**Agenda Item:** 14.1, 14.2

**Source:** NTT DoCoMo

**Title:** Proposed Introduction of DL Timing Adjustment command in lur/lub user plane protocols

Figure 7. FACH/PCH Timing Adjustment procedure activated by DL Timing Adjustment reception.

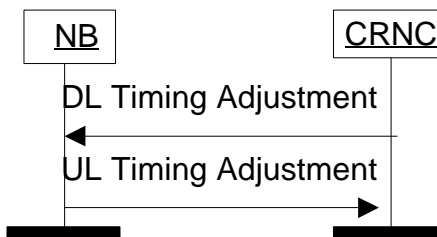
Timing Adjustment procedure is used to indicate for the CRNC the incorrect arrival time of downlink data or DL Timing Adjustment control information to node B.

Timing adjustment procedure is initiated by the node B if a DL data frame or the DL control frame containing DL timing adjustment arrives outside of the defined arrival window.

If the DL frame has arrived before the ToAWS or after the ToAWE nodeB includes the ToA and the target Cell SFN as message parameters for UL TIMING ADJUSTMENT Control Frame.

**Figure 9. DSCH Timing Adjustment procedure activated by DL Timing Adjustment reception.**

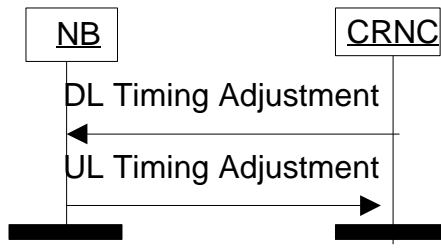
Timing Adjustment procedure is used to indicate the incorrect arrival time of downlink data or DL Timing Adjustment control information for the CRNC.

Timing adjustment procedure is initiated by the node B if a DL data frame or the DL control frame containing DL timing adjustment arrives outside of the defined arrival window.

If the DL frame has arrived before the ToAWS or after the ToAWE nodeB includes the ToA and the target Cell SFN as parameters to the UL TIMING ADJUSTMENT Control Frame
